STATE OF NORTH CAROLINA  
DEPARTMENT OF TRANSPORTATION

April 21, 2004

Subject: **Response to USACE Comments for Application for Individual Section 404 and 401 permits** for the US 17 widening from SR 1327/1410 north of Jacksonville to SR 1330/1439 south of Belgrade/Maysville in Onslow County, North Carolina Federal Aid Project No. NHF-17(7) State Project No. 8.T190301, WBS Element 34442.1.1

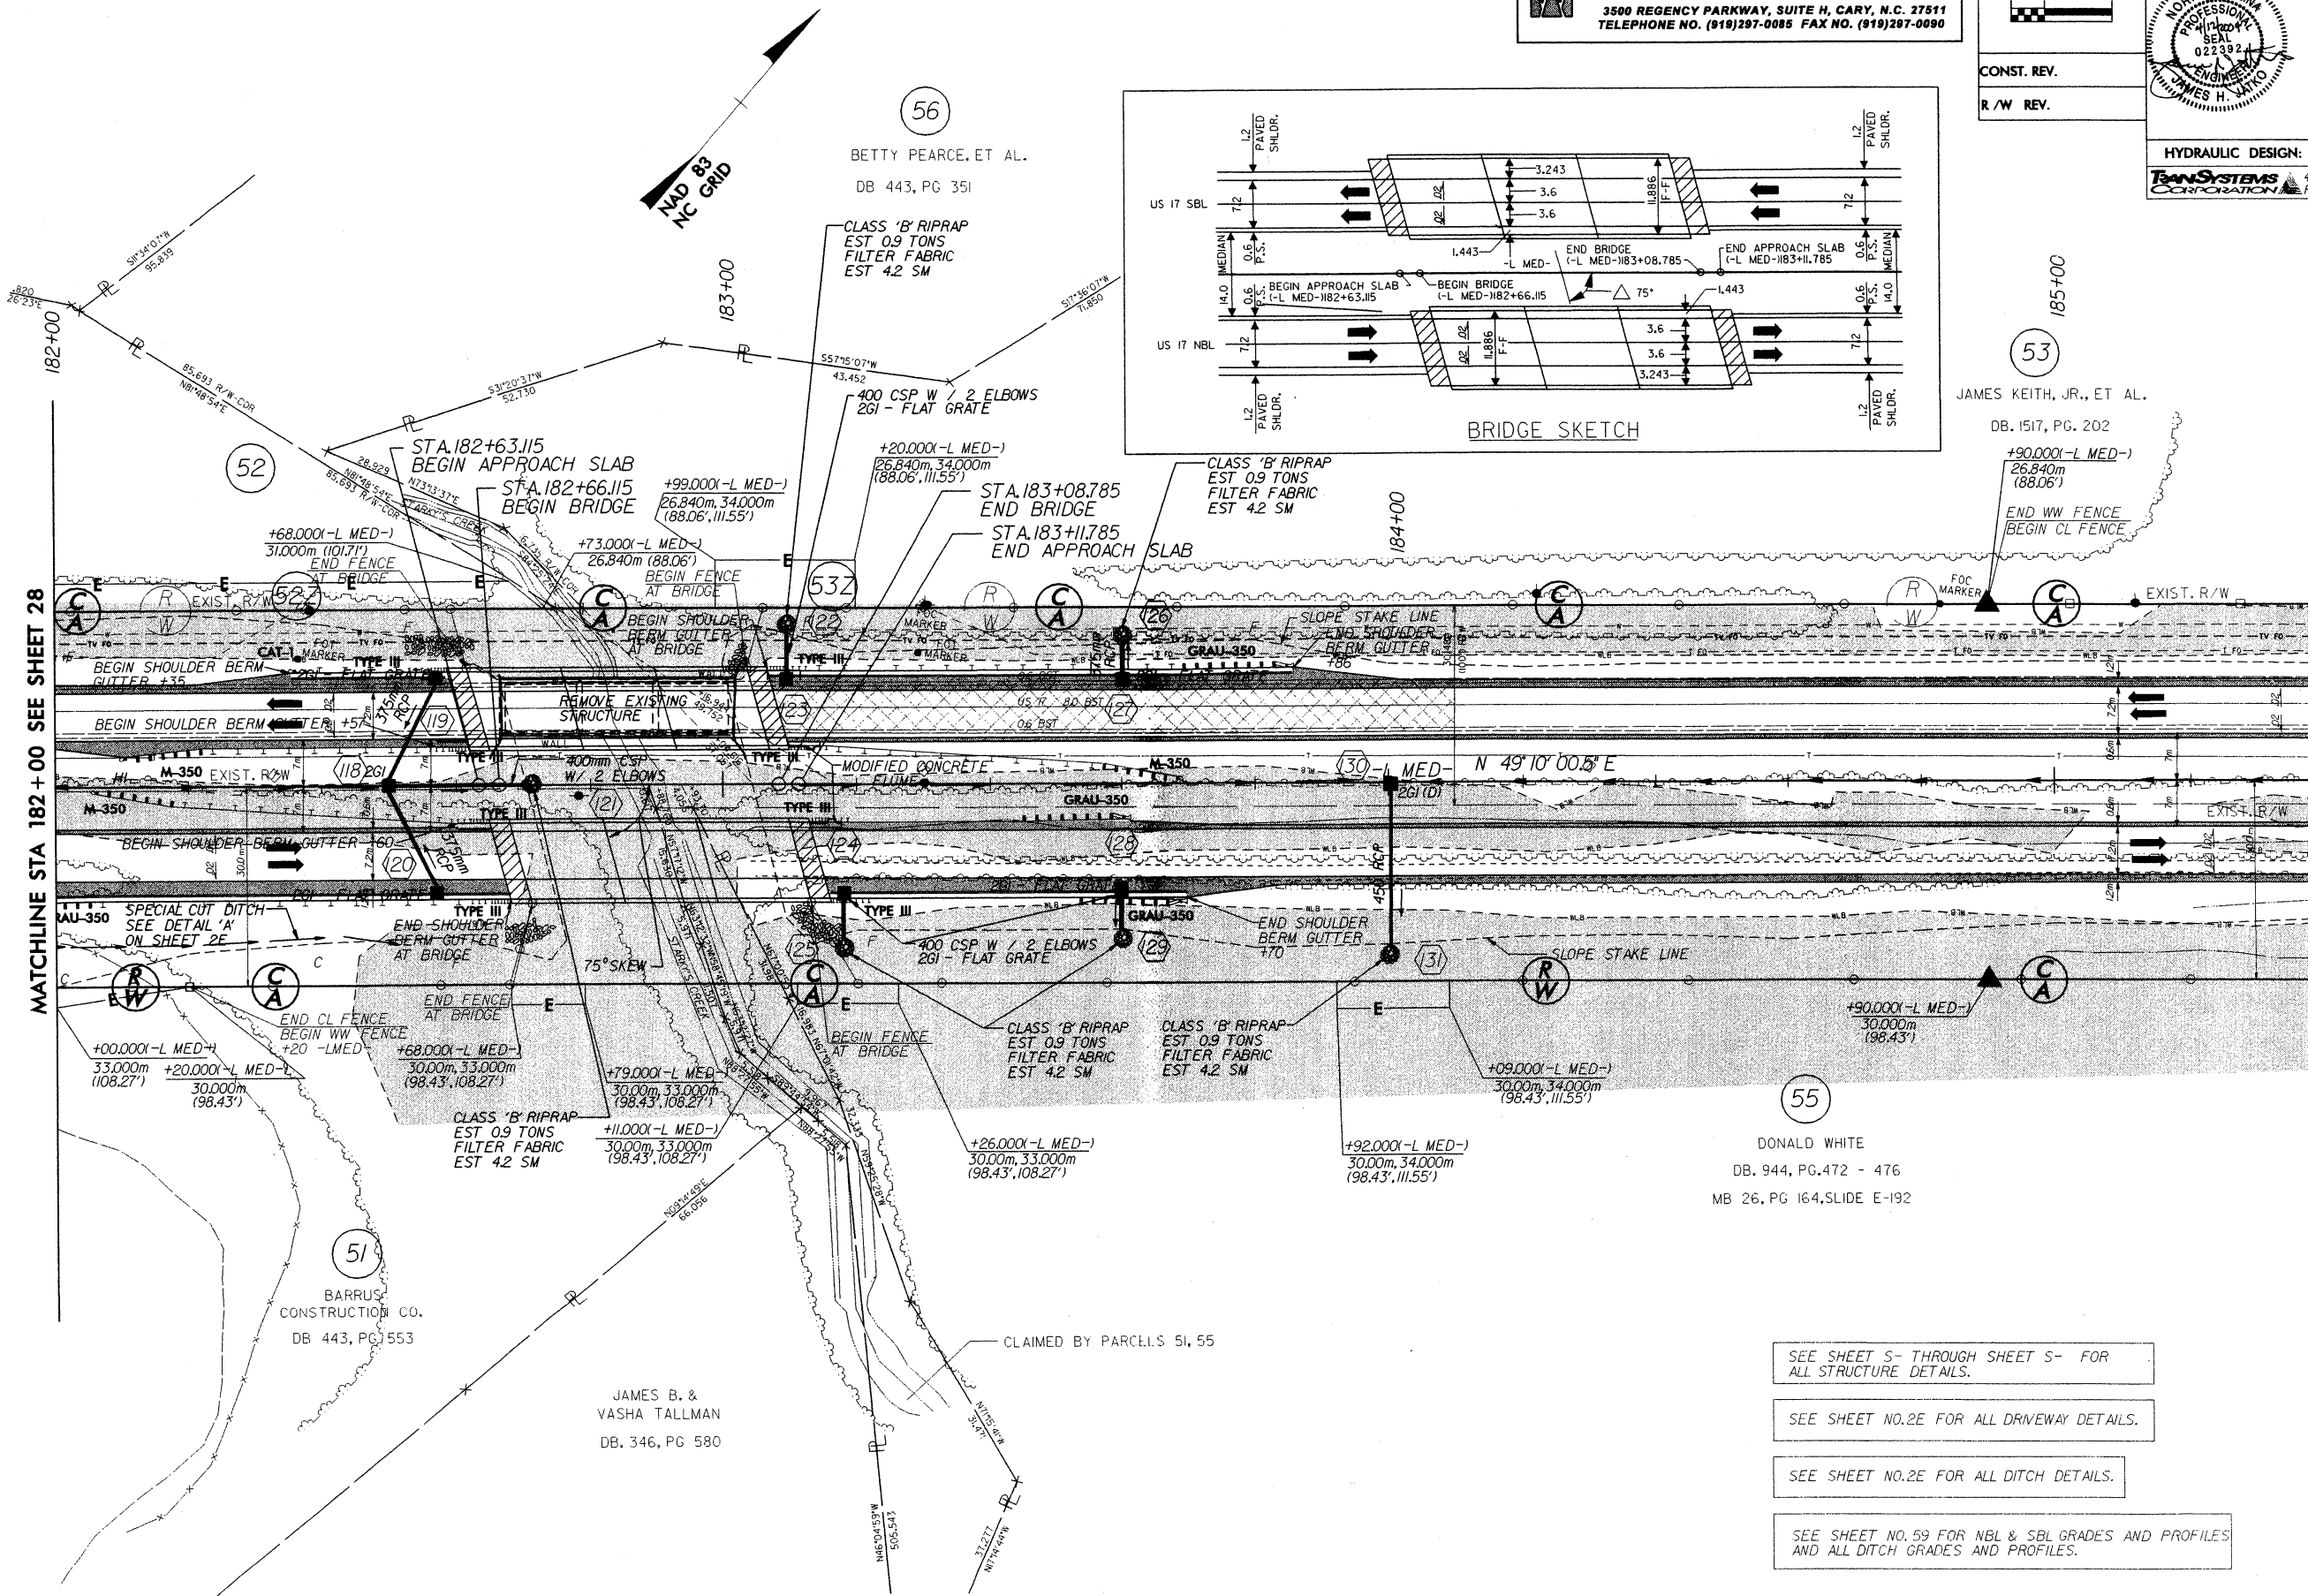
*9. The permit application proposes to replace the existing bridge over Starkys Creek, Wetland Site 55 and 56, with a cored-slab bridge by using top down construction methods and remove the existing bridge by utilizing temporary work pads constructed in wetlands but within the footprint of the proposed permanent impacts. Based on the permit drawings 61-64 dated April 8, 2003, it is not clear if the permanent fill for the temporary work pads and access roads, including all the temporary pipes and box culverts, is needed for removal of the existing bridge. Although we fully support the proposal to use top down construction methods, we feel removal of the existing bridge can be accomplished without incurring permanent wetland impacts (and associated compensatory mitigation) associated with the work pads and access roads. Moreover, as stated on page 10 of the permit application, the Division of Coastal Management letter dated November 25, 1999 prohibits construction staging areas in wetlands as a condition of its consistency determination. Thus, we highly recommend that the proposed work pads and access roads be replaced with a work bridge that will only result in temporary wetland impacts. We also recommend that the NCDOT Division 3 be consulted on the proposed removal and replacement methods for this bridge. Lastly, it is not clear from the information provided how or where the existing US 17 traffic will be detoured during construction. The traffic detour plan should also be provided.*

**Plan Sheet 29:** John noted that the proposed bridges were slightly longer than the existing bridge. No further discussion or action was determined to be necessary.

The traffic will be shifted using cross-overs inside the median. The impact of these cross-overs (Detours) have been shown on the plans since the early stages of the project design and can be seen on sheets 28 and 29 of roadway plans. The construction activity should not interfere with the traffic flow.
